**CUT/FILL PLAN**
SCALE 1:1500

PROJECT PROPOSED WAREHOUSE DISTRIBUTION AUGUSTA STREET, HUNTINGWOOD EAST, NSW 2148	DESIGNED LDV	DRAWN JB	DATE JUNE '22	CHECKED MW	SIZE B1	SCALE AS SHOWN	CAD REF: C013904.03-SSDA310
--	-----------------	-------------	------------------	---------------	------------	-------------------	--------------------------------

DRAWING TITLE CUT/FILL PLAN	DRAWING No C013904.03-SSDA310	ISSUE D
--------------------------------	----------------------------------	------------

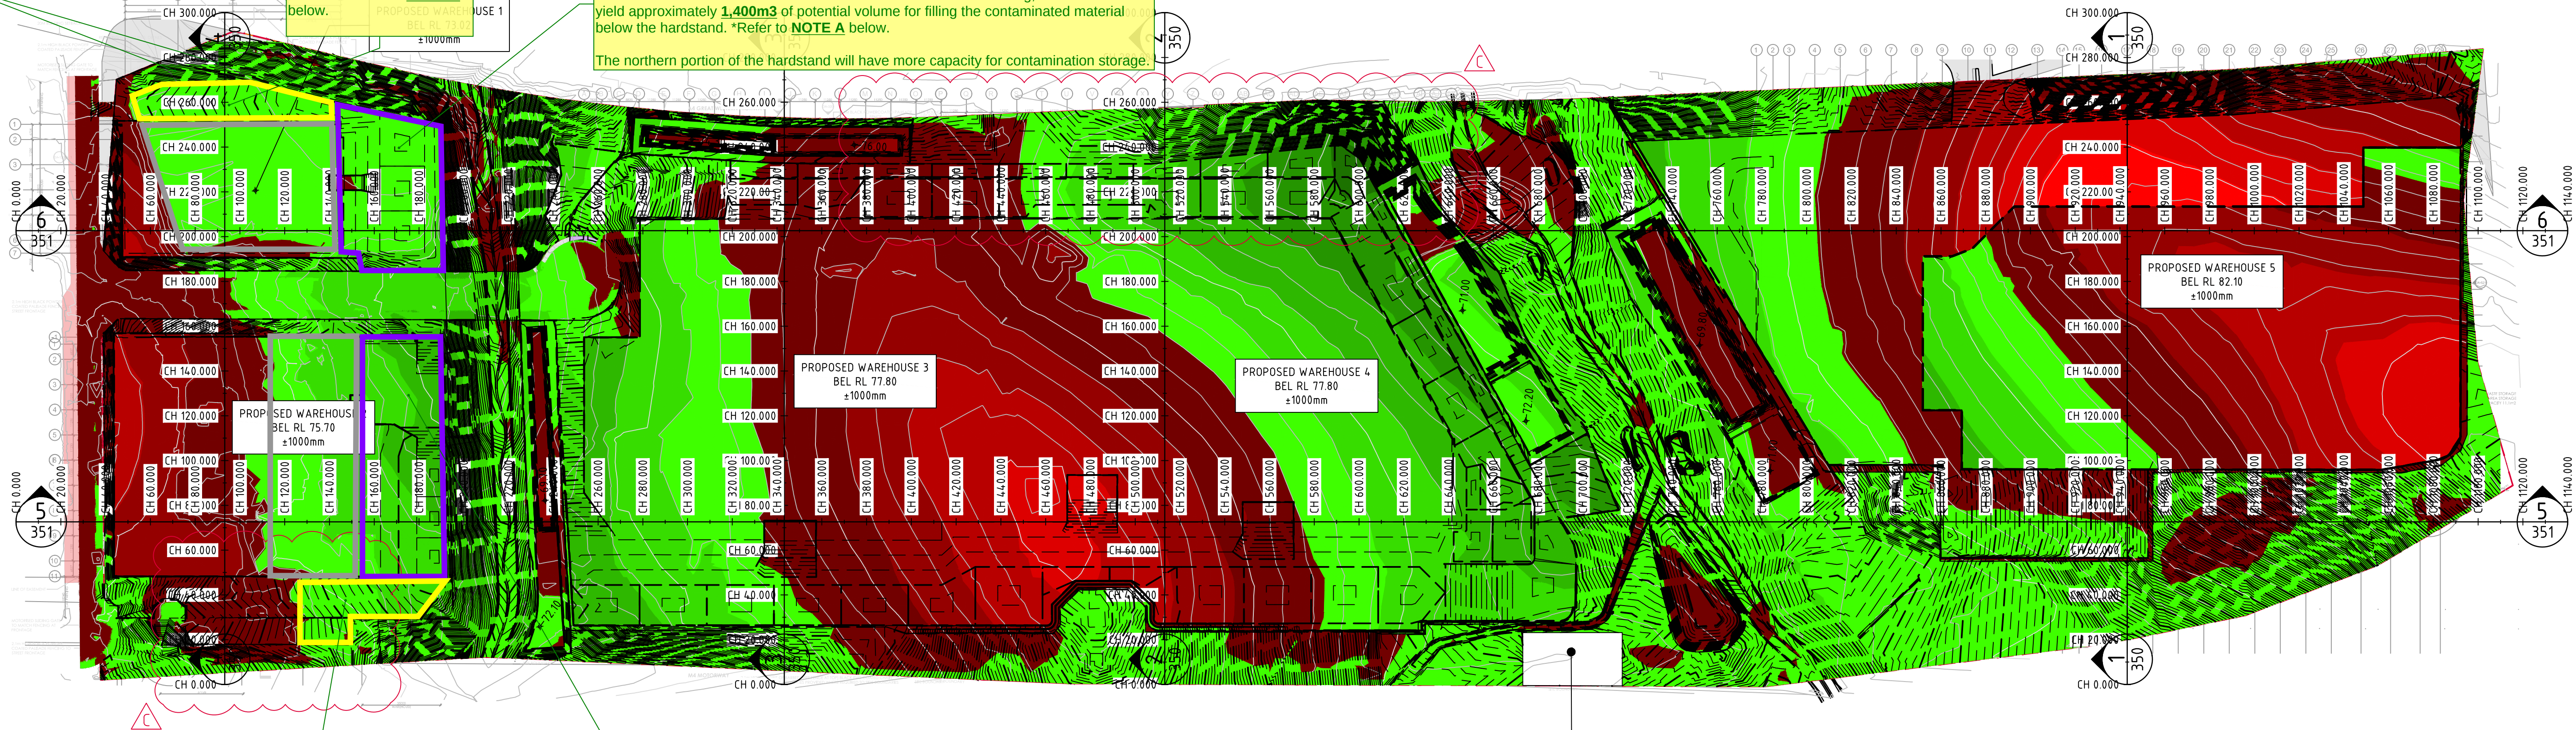
Recent request from client to keep existing levels outside car park to retain trees, no opportunity for capping

Some opportunity to utilise the fill below the carpark for capping of contaminated material. *Refer to **NOTE A** below.

Assessed the feasibility of capping the contaminated material beneath the hardstand. Allowing for a 500mm cap over the contaminated material, excluding the OSD tank's volume of approximately 700m3, spoil for services @ 1500m3/ha and starting the fill of the contaminated material at least 1V:1H from the face of the building, the area would yield approximately **1,400m3** of potential volume for filling the contaminated material below the hardstand. *Refer to **NOTE A** below.

The northern portion of the hardstand will have more capacity for contamination storage.

Assessed the feasibility of capping the contaminated material beneath the carpark. Allowing for a 500mm cap over the contaminated material and excluding the OSD tank's volume of approximately 1,200m3, spoil for services @ 1500m3/ha and starting the fill of the contaminated material at least 1V:1H from the face of the building, would area yield approximately **8,000m3** of potential volume for filling the contaminated material below the hardstand. *Refer to **NOTE A** below.

Assessed the feasibility of capping the contaminated material beneath the hardstand. Allowing for a 500mm cap over the contaminated material, and excluding the OSD tank's volume of approximately 1,200m3, spoil for services @ 1500m3/ha and starting the fill of the contaminated material at least 1V:1H from the face of the building, would area yield approximately **8,000m3** of potential volume for filling the contaminated material below the hardstand. *Refer to **NOTE A** below.

HERITAGE SITE SHOWN THUS. NO WORKS WITHIN HERITAGE ZONE. MATCH LEVELS AT BOUNDARY OF HERITAGE SITE.

No remediation works proposed within the the floodway.

NOTE A:
The geotechnical engineer to verify the suitability of the contaminated material for foundation (bearing capacity), provide insights into the long- and short-term modulus (E value) of the soil, -CBR value, guidance on shrinkage and swelling, identification of material type, and related recommendations.

SECTION 2
HORIZONTAL SCALE 1:1000
VERTICAL SCALE 1:200

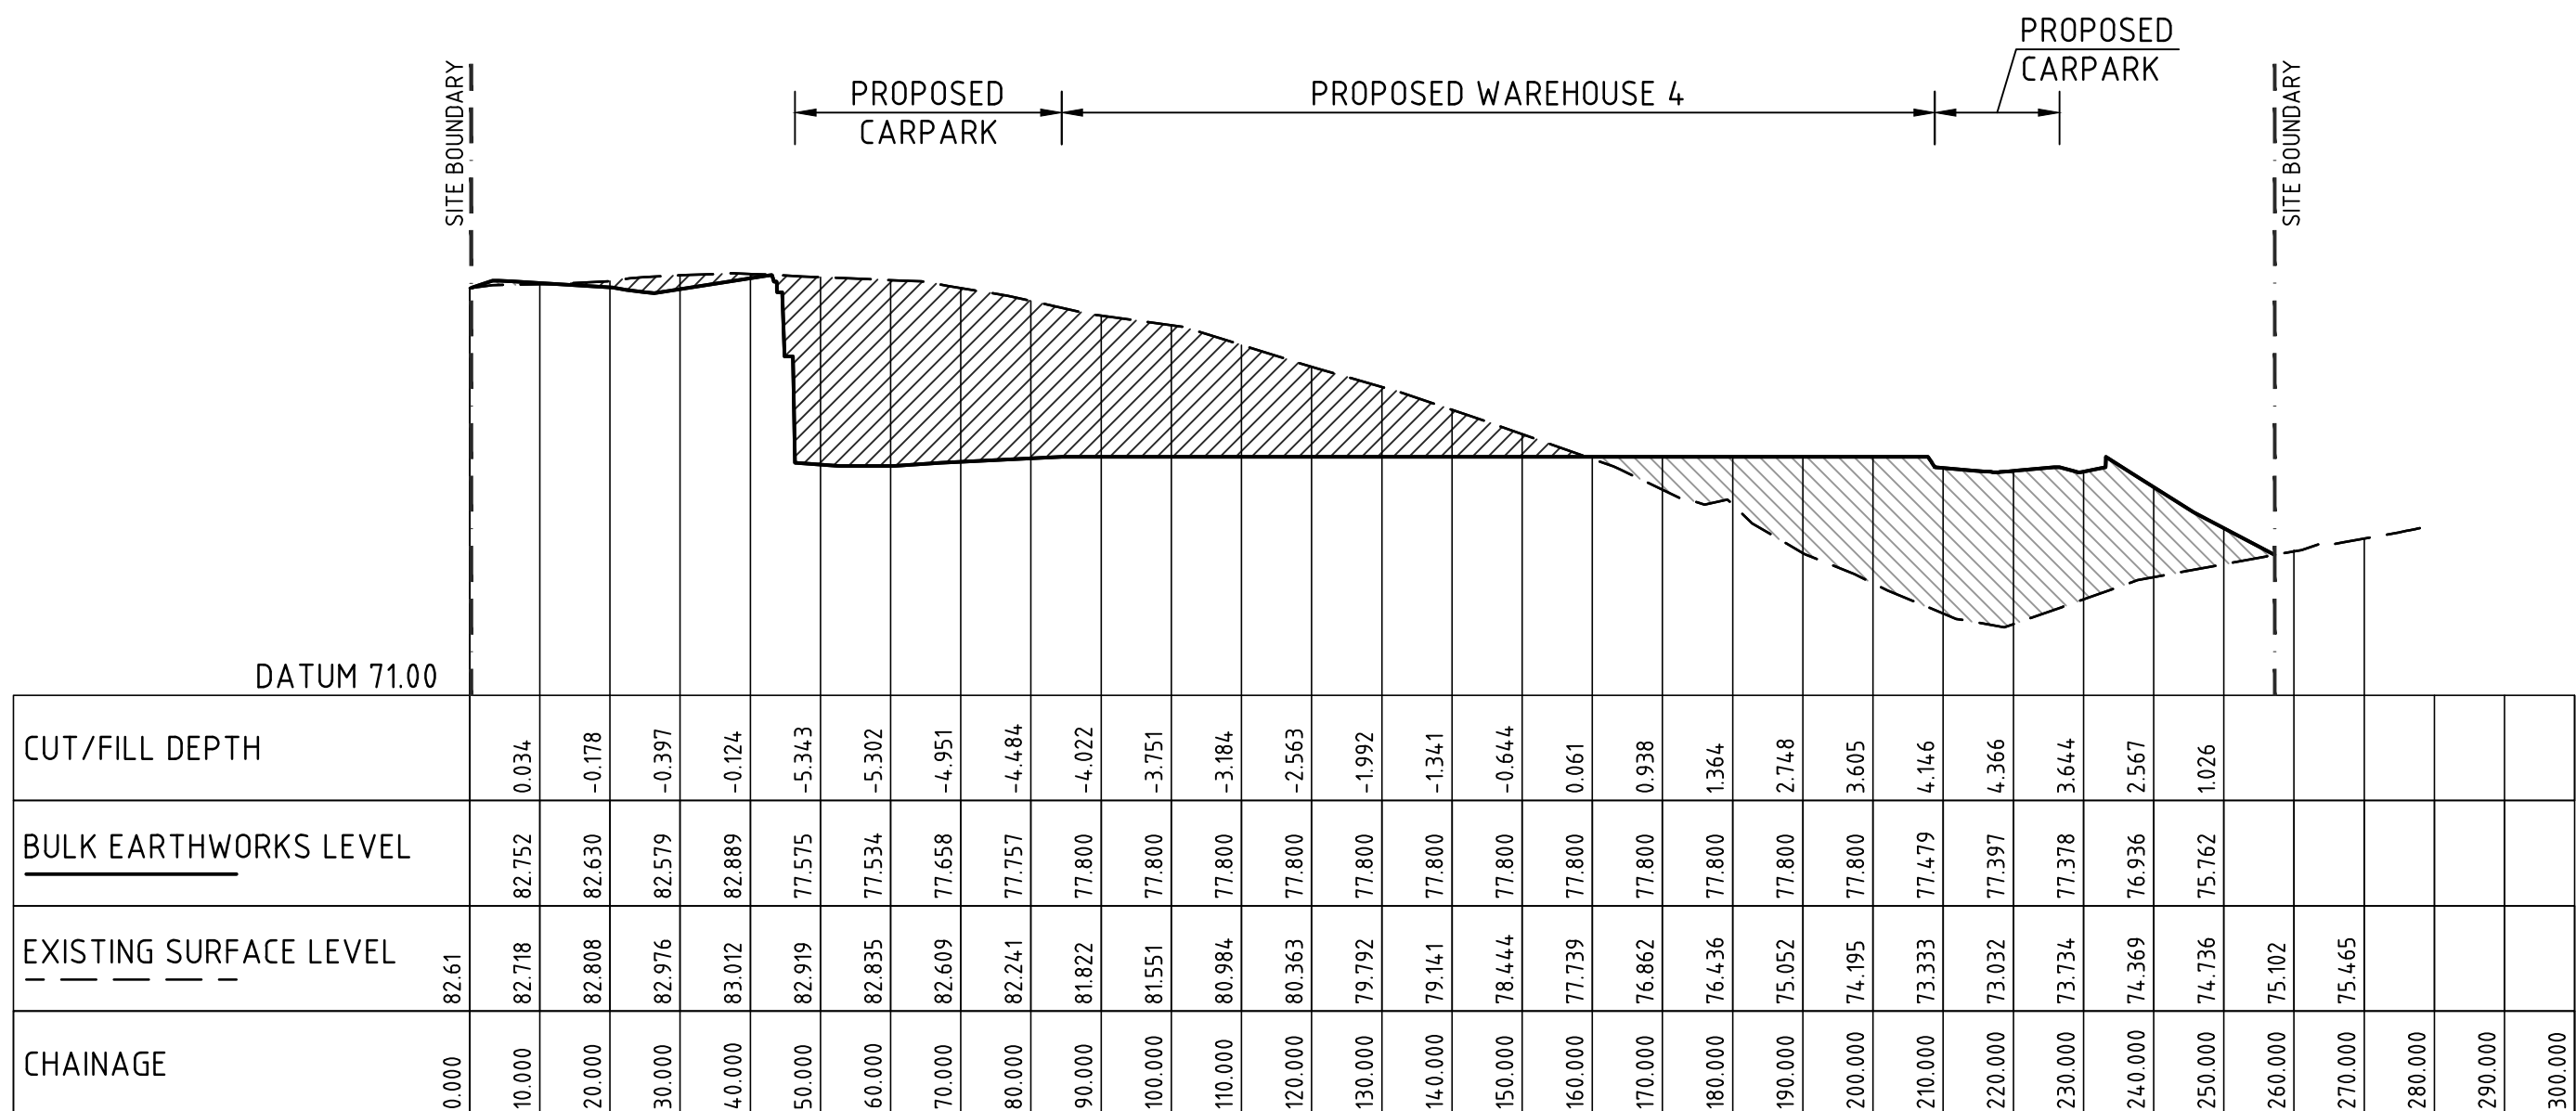
No remediation works proposed within the the floodway.

Impacted fill will be managed to the extent achievable via containment and the implementation of permanent physical separation which eliminates the inhalation exposure pathway for airborne asbestos fibres

SECTION 4
HORIZONTAL SCALE 1:1000
VERTICAL SCALE 1:200

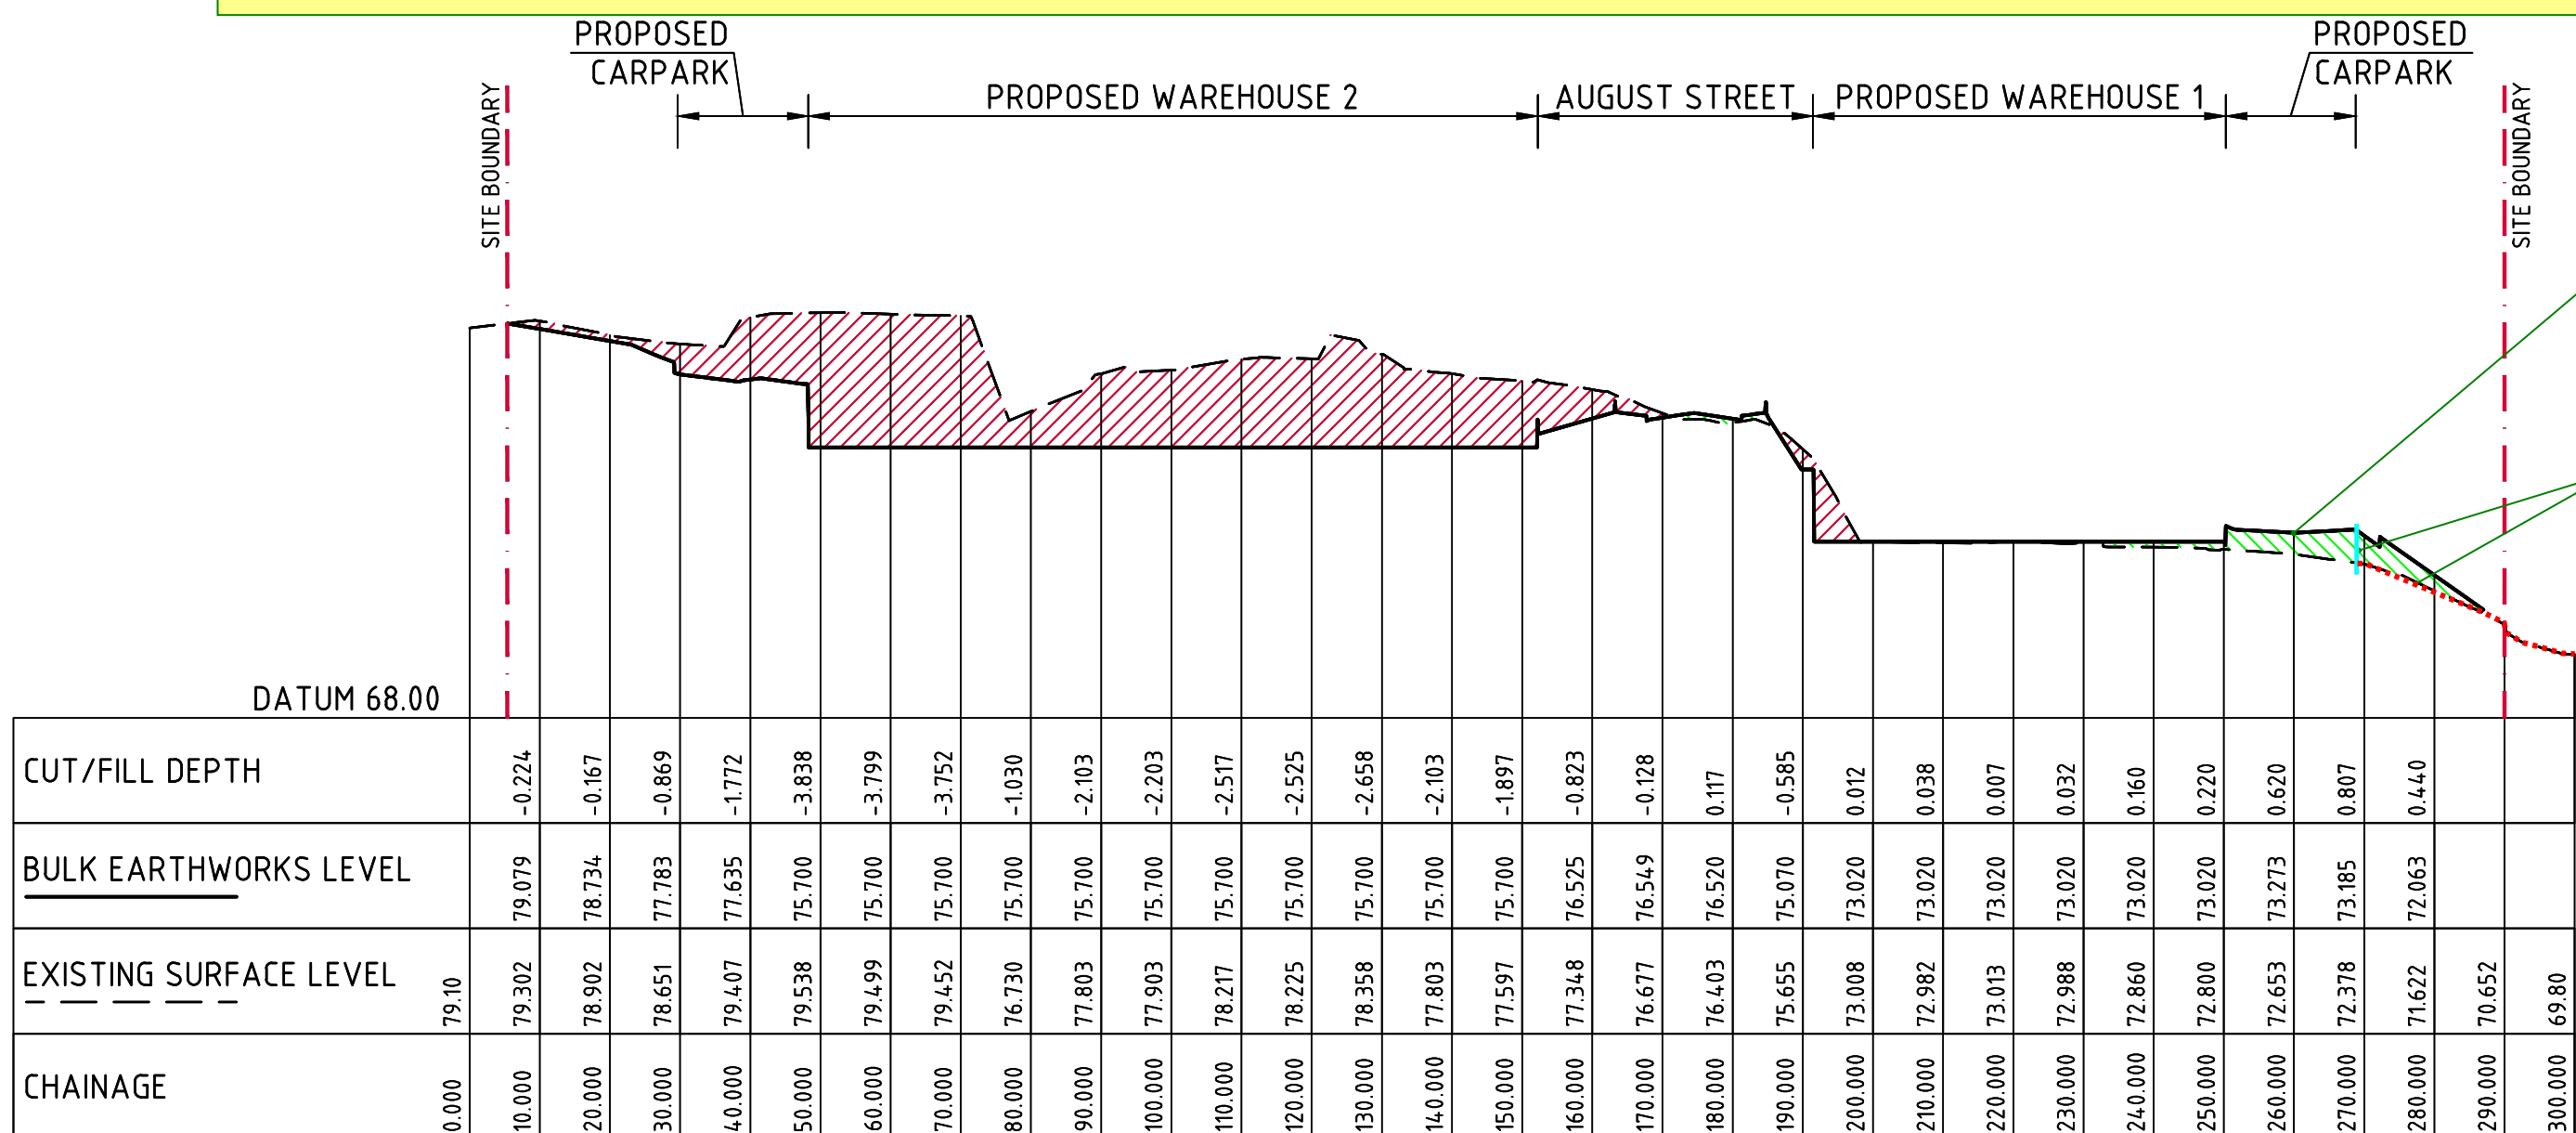
The materials to be contained onsite under a marker and capping layer (that comprises 0.5 m of clean capping material and/or hardstand);

Recent request from client to keep existing levels outside car park to retain trees, no opportunity for capping.
